ADDENDUM NUMBER 4:  
Bid#10-16  
South Mill Pond Tennis Courts, Leary Ball Field Lighting and Portsmouth High School Lighting  
Issued: January 11, 2015

This Addendum forms part of the original document marked: Bid#10-16 South Mill Pond Courts, Leary Field Lighting and Portsmouth High School Lighting.

SOUTH MILL POND TENNIS COURTS, LEARY BALL FIELD LIGHTING, AND  
 PORTSMOUTH HIGH SCHOOL LIGHTING  
 Rockland Street and Andrew Jarvis Drive, Portsmouth, NH

**SK-3**

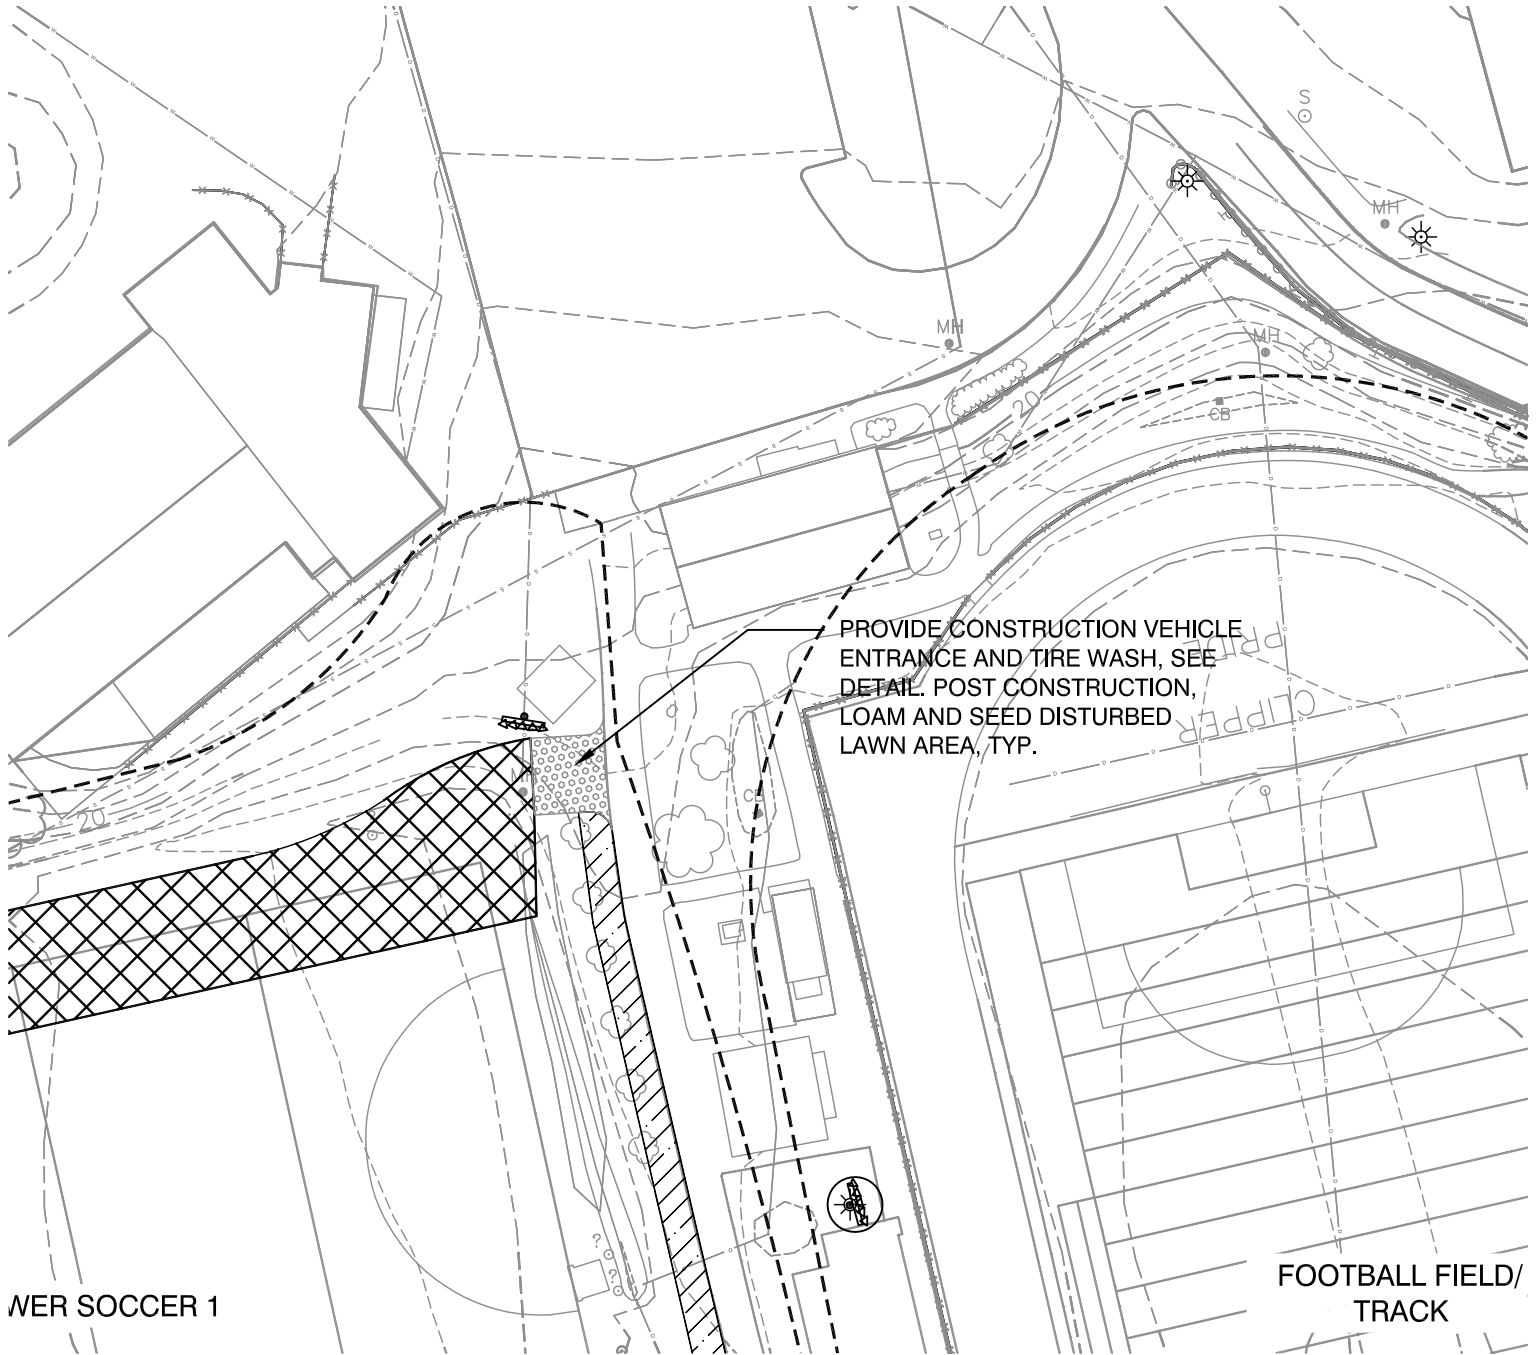
**Question 4:** Please clarify the limits of base bid curbing. If alternate 3 is not accepted then where does this curbing end?

**Question 5:** In base bid, does the bituminous concrete walkway wrap around the corner at the southwest corner? Please confirm the limits of the bituminous concrete walks.

1. Sheet L4.01 provide revisions as indicated on sheet SK-3
2. Sheet L3.03 provide revisions as indicated on sheet SK-4
3. Sheet L5.02 provide revisions as indicated on sheet SK-5

**Answer:** *Please refer to the attached sheet SK-3 for clarification.*

*Yes, in the base bid, the bituminous concrete walk will wrap around the southwest corner of the tennis courts and meet with the existing pathway. Please refer to the attached sheet SK-3 for further clarification.*
